RAIDER OUTBOARDS SERVICE BULLETIN NR. RO2019-001 (April 25, 2019) formally NR. 001

1. Raider update on defective parts and recommended corrective actions/upgrades.
2. Motor applicability: Raider 50HP and 40HP Outboards.
3. **Carburetor Fuel Bowls.** Should installed fuel bowl(s) be “translucent” plastic construction **PLACE ENGINE OUT OF SERVICE UNTIL REMEDIED**. The translucent fuel bowl(s) will potentially leak at the carburetor flange, releasing fuel into cowling that may result in a fire. (see fig1 and fig2)

Fig (7) Raider 40HP with USCG compliant lines installed

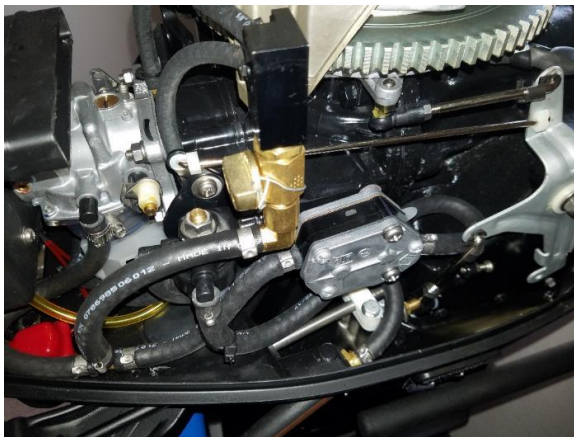
5. **Fuel Lines.** Replace all clear (yellow) fuel line(s) with USCG compliant Reinforced BLACK gasoline/diesel fuel compatible fuel line(s). Black fuel line is more resistant to heat and chemical degradation. Replace at earliest maintenance or repair availability. (see fig and 8)
